BUILDING PERMIT

Located At 273 SPRING ST

Job ID: 2011-09-2290-ALTR

has permission for Interior renovations to existing space (non-structural).

**FIGURE R307.1
MINIMUM FIXTURE CLEARANCES**

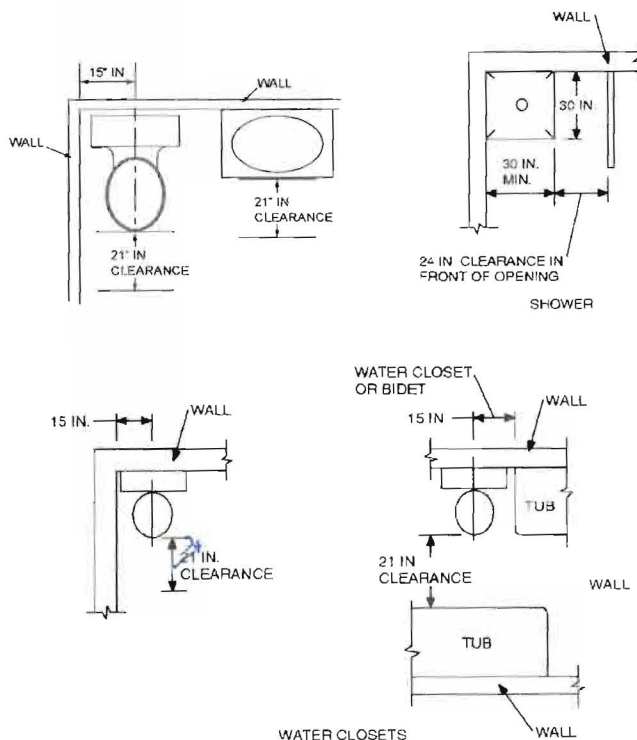
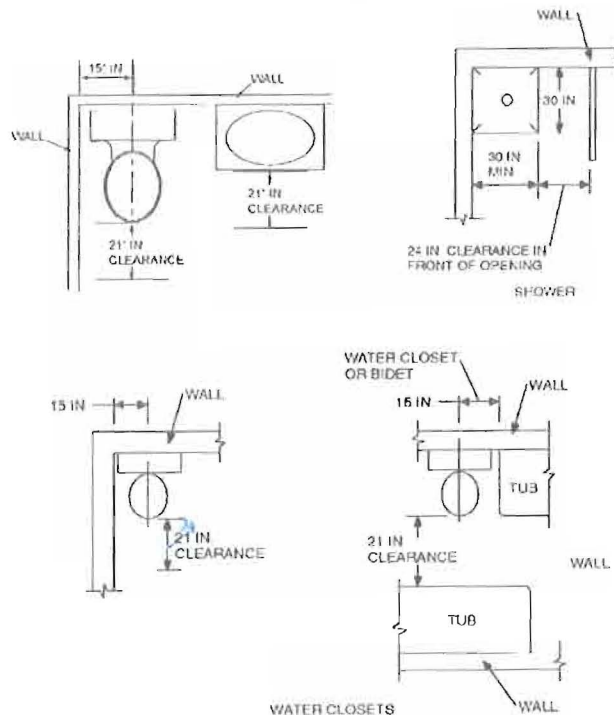
7. See attached documentation for bathroom fixtures clearance and headroom requirements.
8. R302.4 Dwelling unit rated penetrations. Penetrations of wall or floor/ceiling assemblies required to be fire-resistance rated in accordance with Section R302.2 or R302.3 shall be protected in accordance with this section.

R307.1 Space required. Fixtures shall be spaced in accordance with Figure R307.1, and in accordance with the requirements of Section P2705.1.
